**ADDENDUM NO. 2
TO CONTRACT DOCUMENTS FOR THE
UVAS CREEK LEVEE REHABILITATION PROJECT
Project No. 62084001, Task No. 5175, Contract No. C0643**

ADDENDUM NO. 2
Santa Clara Valley Water District
UVAS CREEK LEVEE REHABILITATION PROJECT PHASE 1

**ATTACHMENT 2:
Revised Plan Sheets**

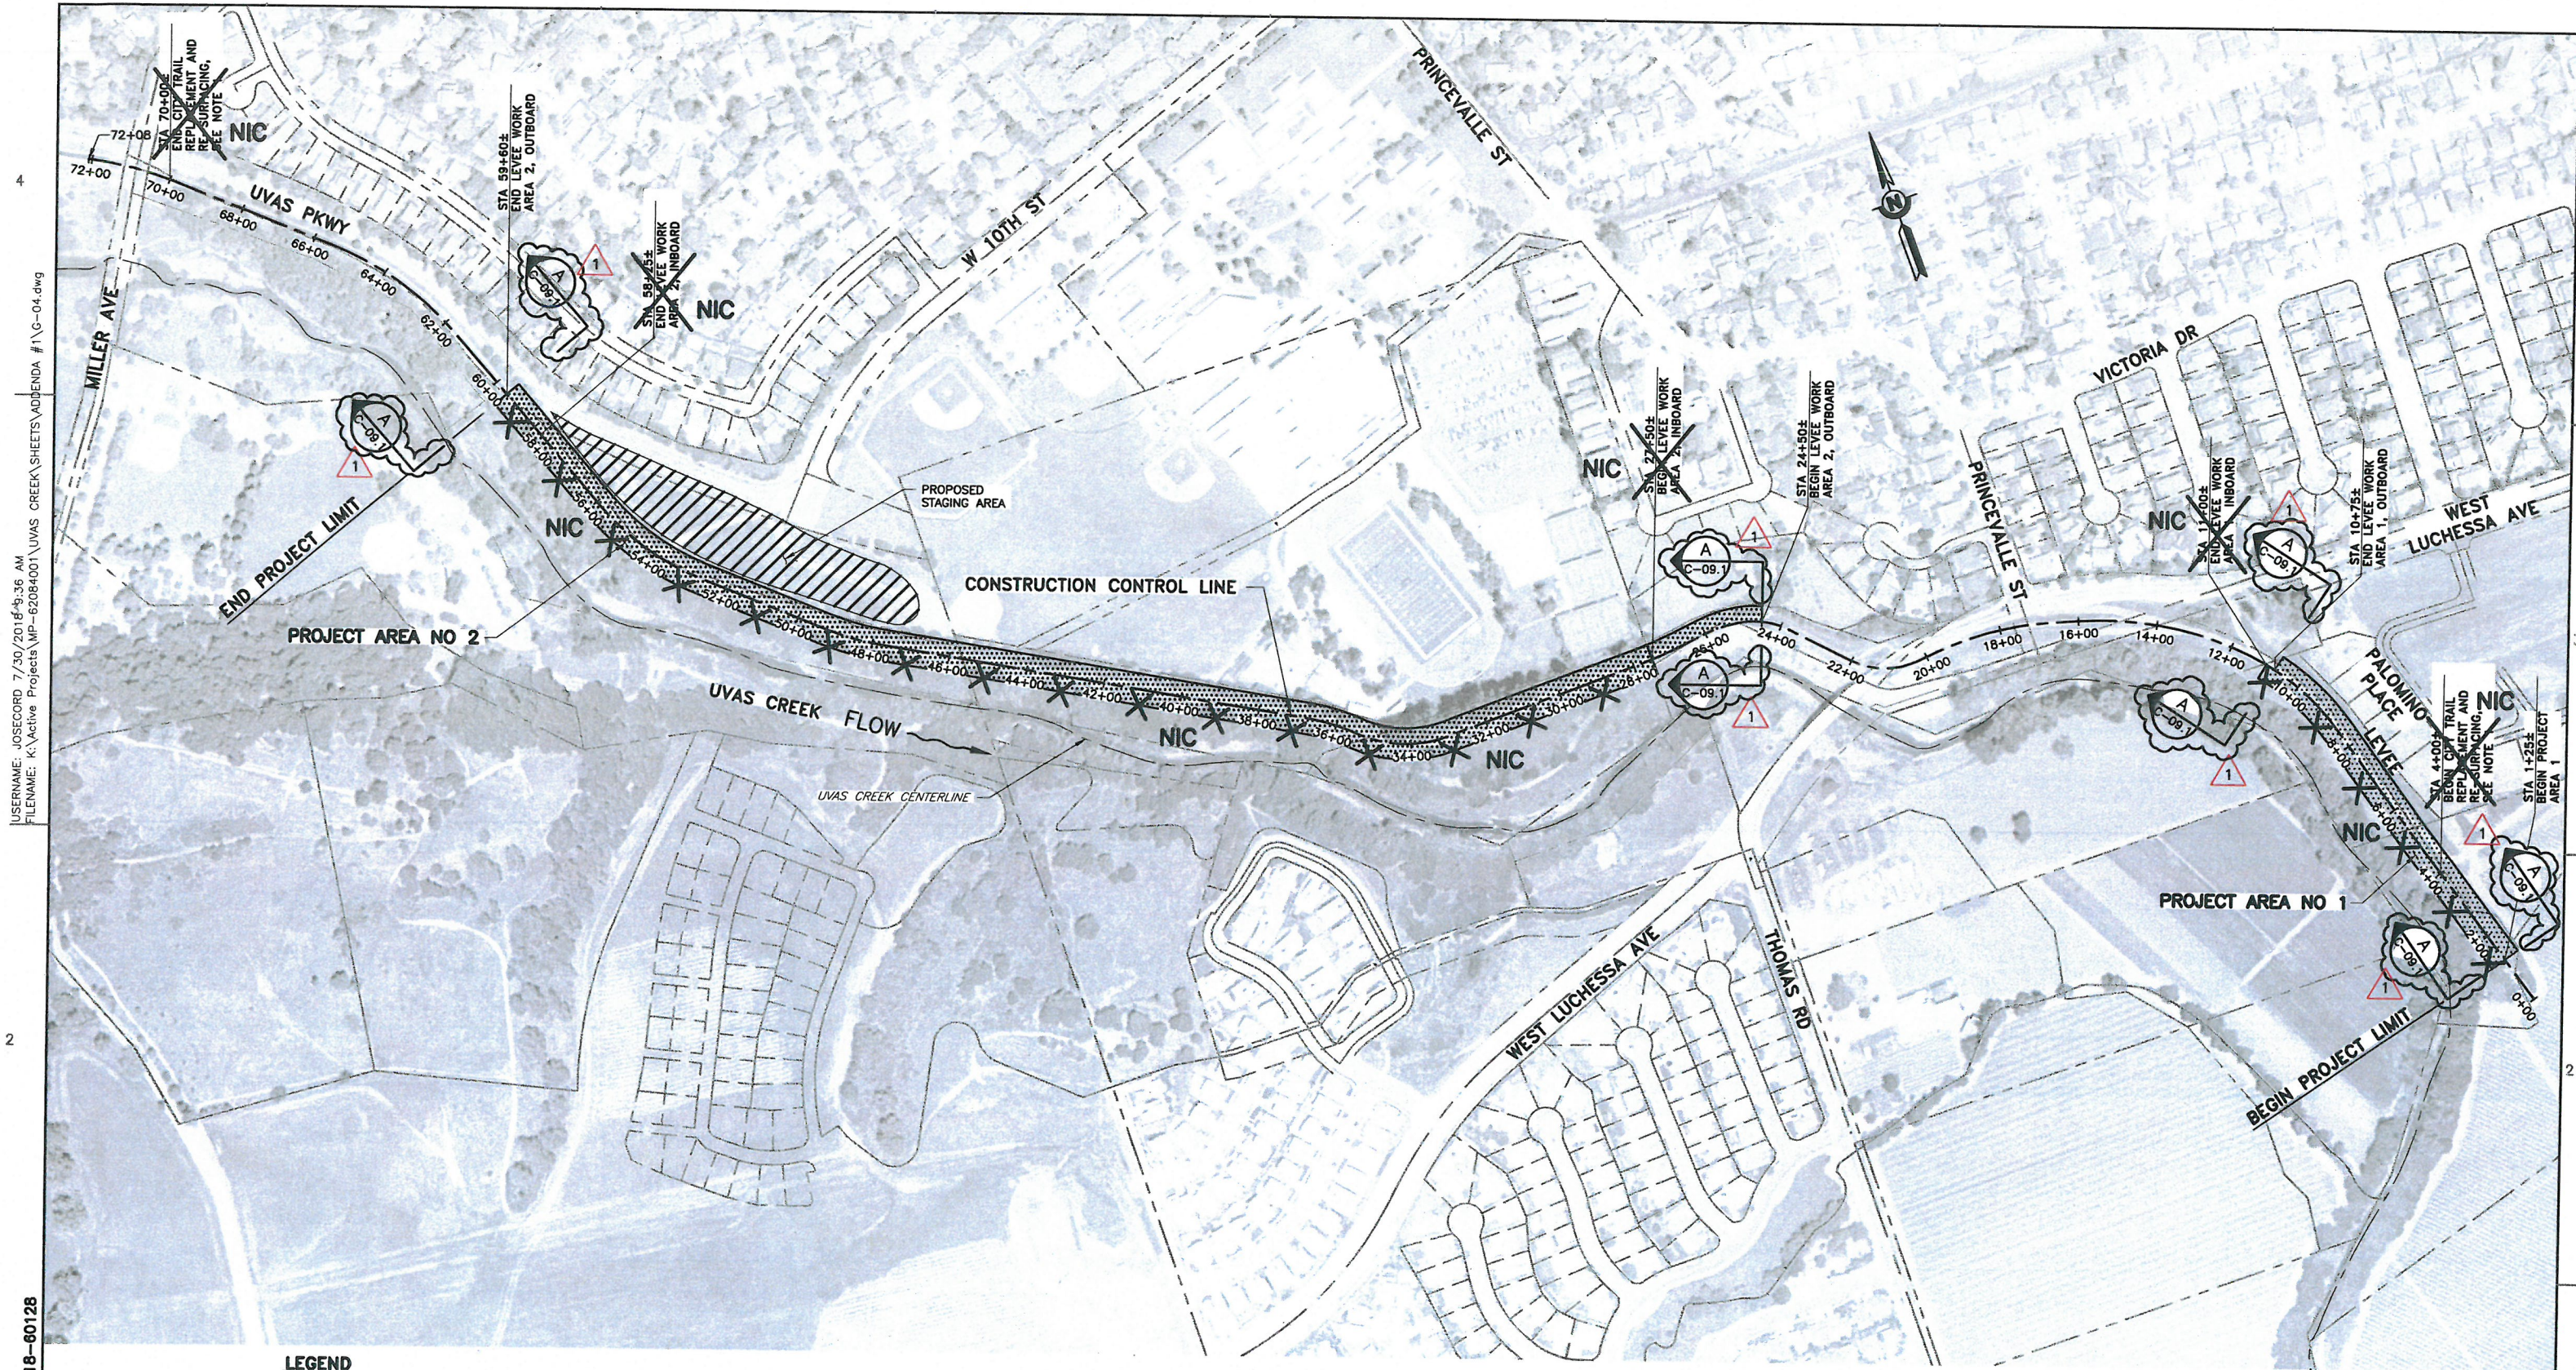
REV	DESCRIPTION	DATE	APPR	REFERENCE INFORMATION AND NOTES	DATE	ENGINEERING CERTIFICATION	PROJECT NAME AND SHEET DESCRIPTION:	SCALE	PROJECT NUMBER
1	ADDENDUM #2	7/18	TI	<p>X SLURRY SEALING WORK IS FROM STA 4+00± TO STA 70+60±. HOWEVER, CITY TO DETERMINE LIMITS FOR AC CRACK REPAIR AND AC REPLACEMENT.</p> <p>NIC</p>	JULY 2018	<p>T. IBARRA DESIGN S.K. / A.A. CHECKED R. NARSIM</p>	<p>UVAS CREEK LEVEE REHABILITATION PROJECT MILLER AVENUE TO END OF LEVEE SITE PLAN AND CONSTRUCTION ACCESS</p>	AS SHOWN	62084001
<p>ADDENDUM #2 07-31-2018</p>					<p>Santa Clara Valley Water District</p>		<p>VERIFY SCALES 0 1" BAR IS ONE INCH ON ORIGINAL DRAWING IF NOT ONE INCH ON THIS SHEET, ADJUST SCALES ACCORDINGLY</p>		
							<p>SHEET CODE: 1 G-04 SHEET NUMBER: 4 OF 30</p>

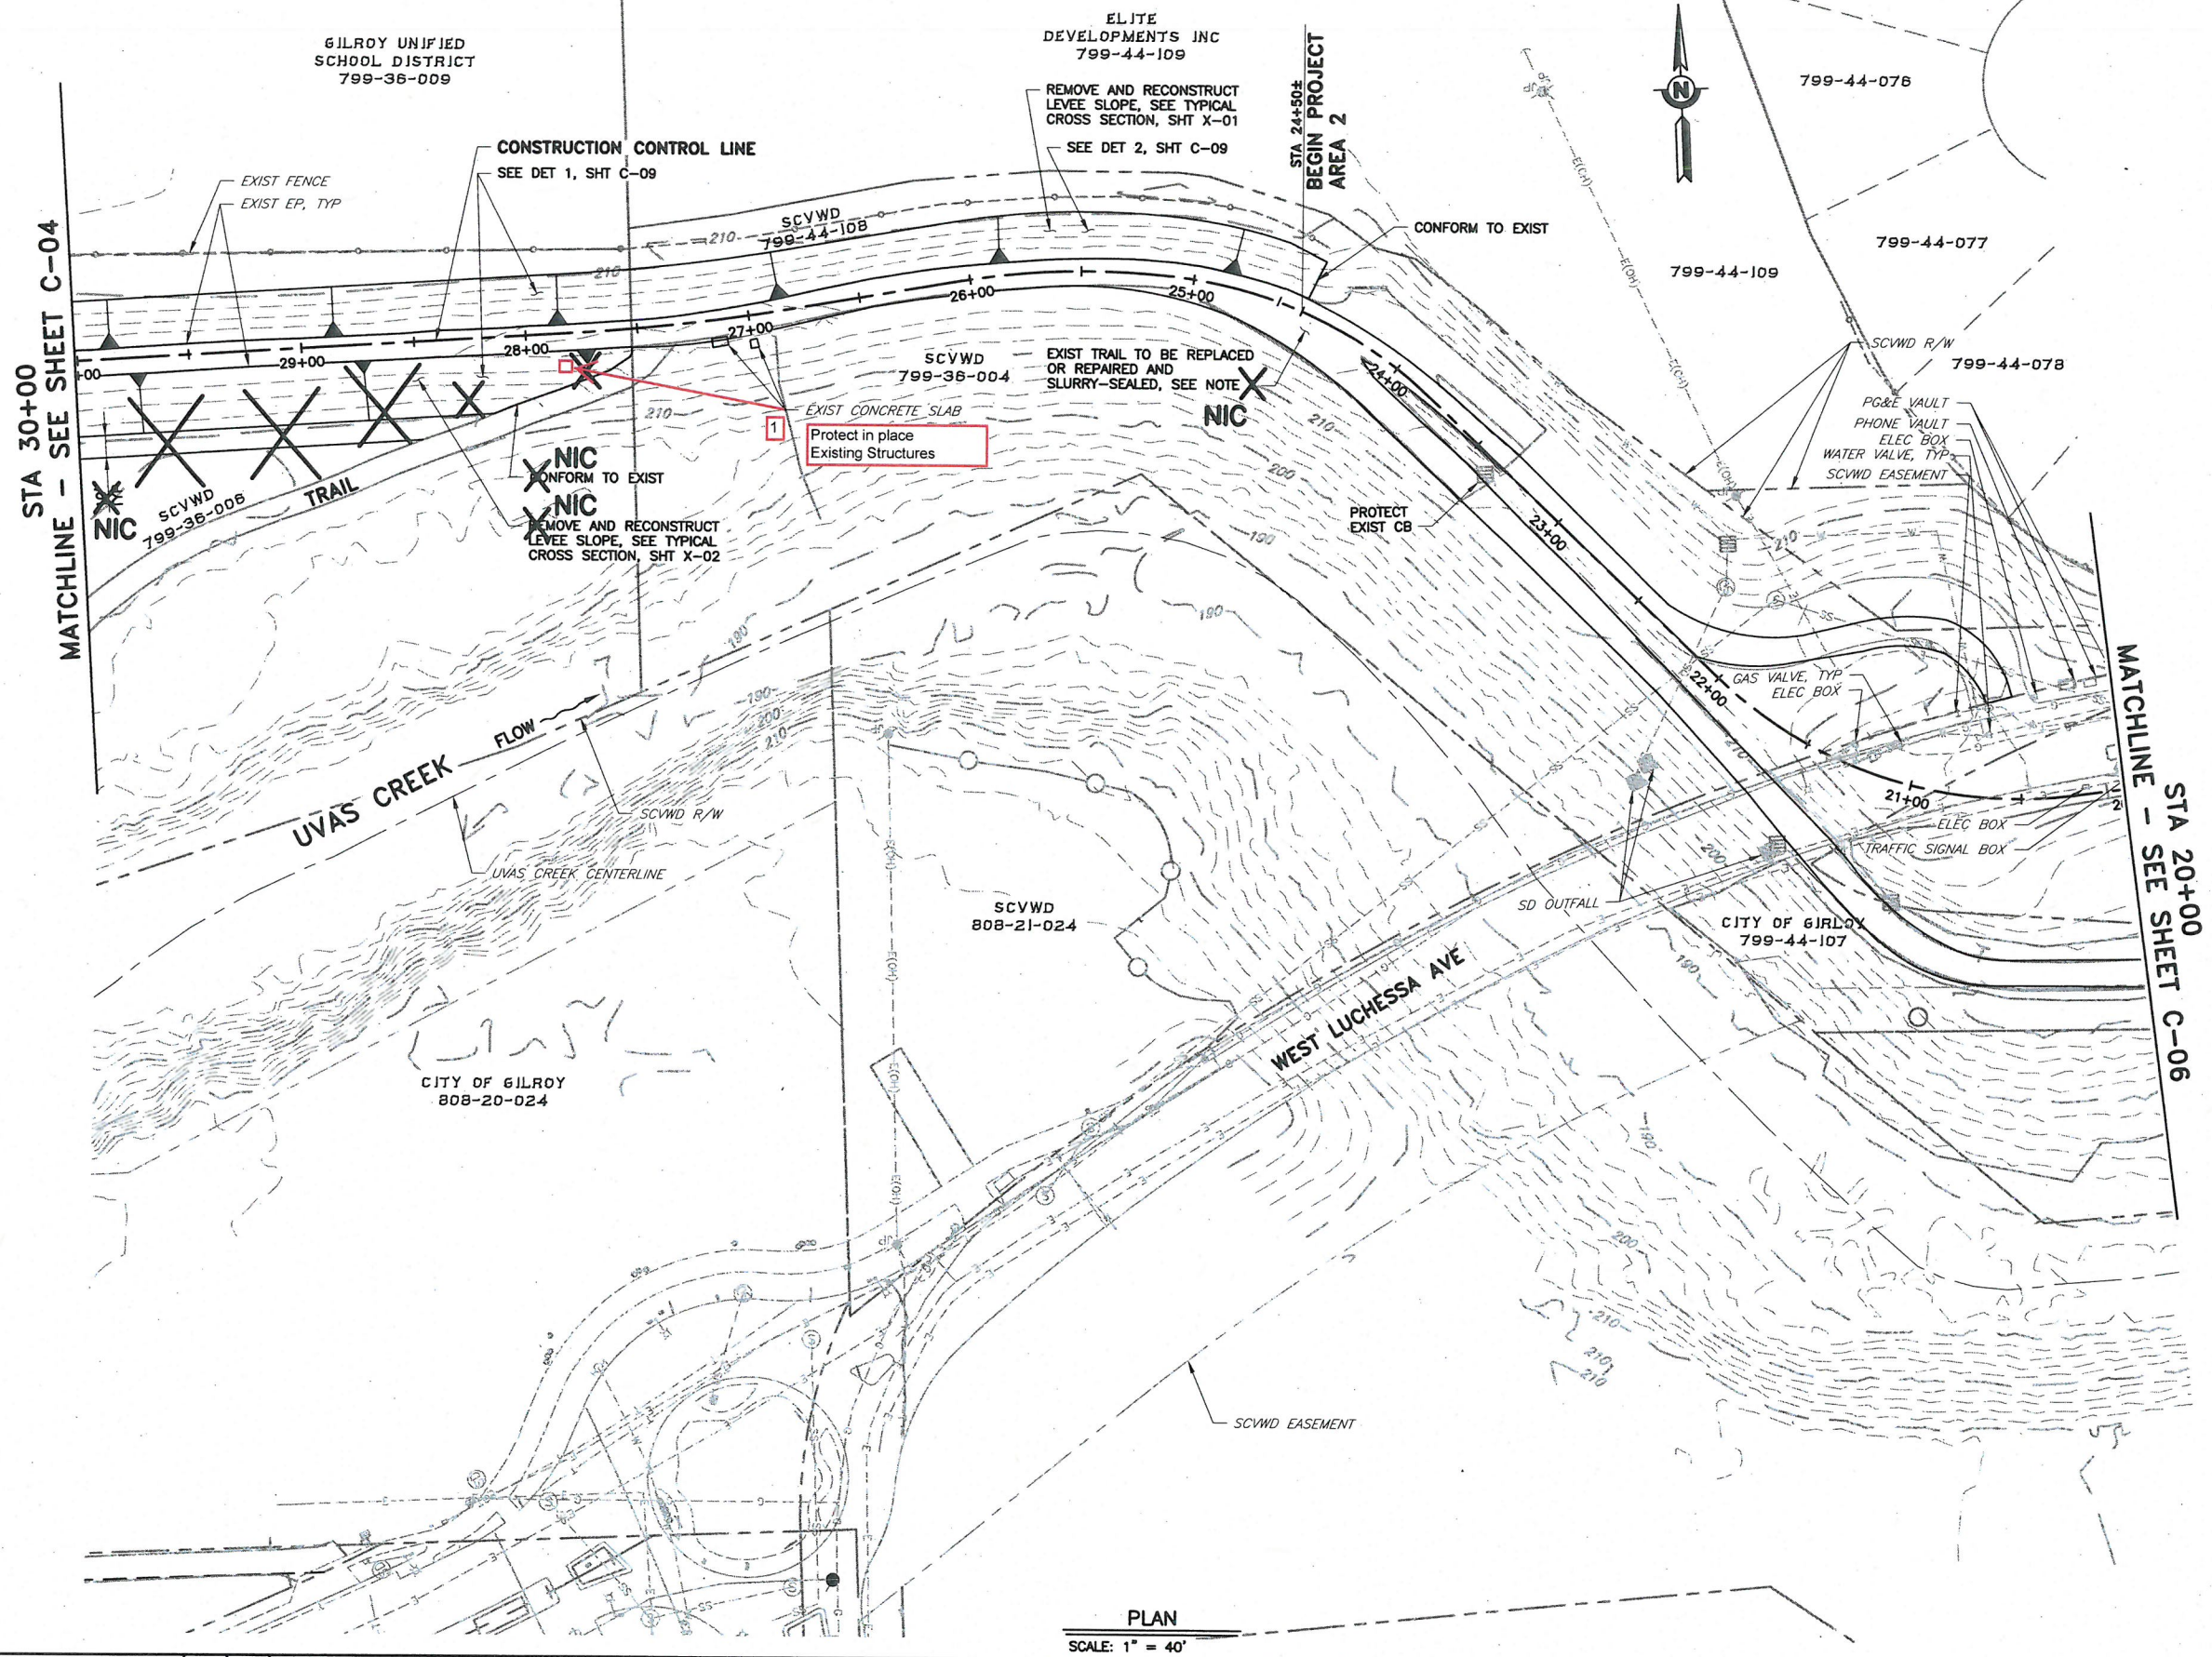
REV	DESCRIPTION	DATE	APPR	REFERENCE INFORMATION AND NOTES	DATE	ENGINEERING CERTIFICATION	PROJECT NAME AND SHEET DESCRIPTION:	SCALE	PROJECT NUMBER
1	ADDENDUM #2 ADDENDUM #2 07-31-2018			X NIC CITY TO DETERMINE LIMITS FOR AC CRACK REPAIR AND AC REPLACEMENT. 2. PER SPECS SECTION 16, CONTRACTOR SHALL ALLOW ACCESS TO HALF OF TRAIL DURING NON-CONSTRUCTION HOURS.	JULY 2018	 T. IBARRA DESIGN DRAWN S.K. / A.A. CHECKED R. NORSIM PROJECT ENGINEER	UVAS CREEK LEVEE REHABILITATION PROJECT MILLER AVENUE TO END OF LEVEE PLAN STA 30+00 TO 20+00	AS SHOWN VERIFY SCALES 0 1" BAR IS ONE INCH ON ORIGINAL DRAWING IF NOT ONE INCH ON THIS SHEET, ADJUST SCALES ACCORDINGLY	62084001 SHEET CODE: C-05 SHEET NUMBER: 22 OF 30
